Access Compliance Report

Public Rights-of-Way

(Curb Ramps)

Intersection ID: 49925	Main Street: PAXTON_RUN_RD	Cross Street: CAMPBELL_HALL_CT	Location: SE
ADA ID: 7977BF94A18F	Ramp Type: Perp	Initial Pass/Fail: Fail	Overall Compliance: No
Codes/Mitigation Info/Possible Solution		Field Measurements/Component Compliance	
Severity Score: 13.75

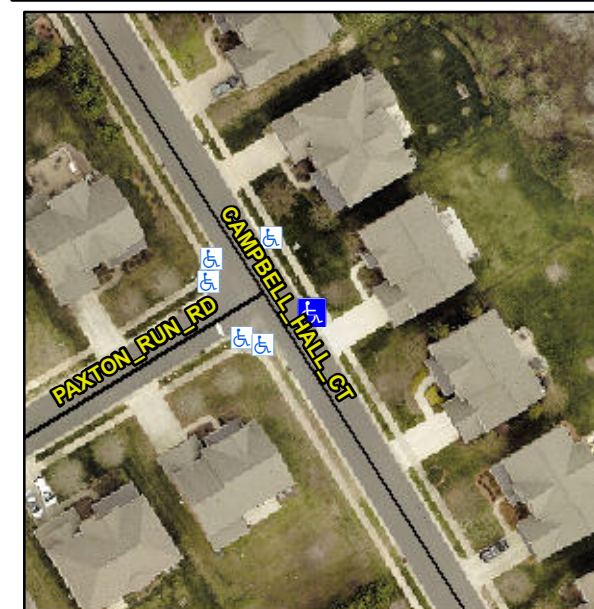
Not Found, R304.2.2, R304.5.3

Compliance	Description	Data	Compliance	Description	Data
N/A	Ramp Length (in)	47.0	No	Ramp Slope (%)	8.6
Yes	Ramp Width (in)	48.0	No	Ramp XSlope (%)	2.3
N/A	Flare Type LT	N/A	N/A	Flare Type RT	N/A
N/A	Flare Slope LT (%)	N/A	N/A	Flare Slope RT (%)	N/A
N/A	Flare Traversable LT?	N/A	N/A	Flare Traversable RT?	N/A
N/A	Landing Length (in)	N/A	N/A	DWS Provided?	N/A
N/A	Landing Width (in)	N/A	N/A	DWS Contrast?	N/A
N/A	Landing Slope (%)	N/A	N/A	DWS Length (in)	N/A
N/A	Landing X Slope (%)	N/A	N/A	DWS Full Width?	N/A
N/A	Landing Curb? (Y/N)	N/A	N/A	DWS Offset (in)	N/A
N/A	Shared Landing?	N/A			
N/A	Gutter Ponding?	N/A	N/A	Gutter Slope (%)	N/A
N/A	Gutter Lip Ht (in)	N/A	N/A	Gutter X Slope (%)	N/A
N/A	Painted X Walk1?	No	N/A	Painted X Walk2?	N/A
	X Walk 1 Direction	To SW		X Walk 2 Direction	N/A
N/A	X Walk 1 Width (in)	N/A	N/A	X Walk 2 Width (in)	N/A
	X Walk 1 Slope (%)	2.6		X Walk 2 Slope (%)	N/A
	X Walk 1 X Slope (%)	0.5		X Walk 2 X Slope (%)	N/A

N/A	Ramp inside XWalk1?	N/A	N/A	Ramp inside XWalk2?	N/A
	Road Slope (%)	N/A	N/A	Clear Space?	N/A
	Road X Slope (%)	N/A	N/A	Clear Space to XWalk (in)	N/A
N/A	Any Obstructions?	N/A	N/A	Storm Grate/Utility Hazard?	N/A
	Obstruction Type			Storm Grate/Utility Type	
		N/A			N/A
			Yes	Surface Condition? (G/P)	Good

Possible Solutions:

Remove & Replace Entire Ramp.
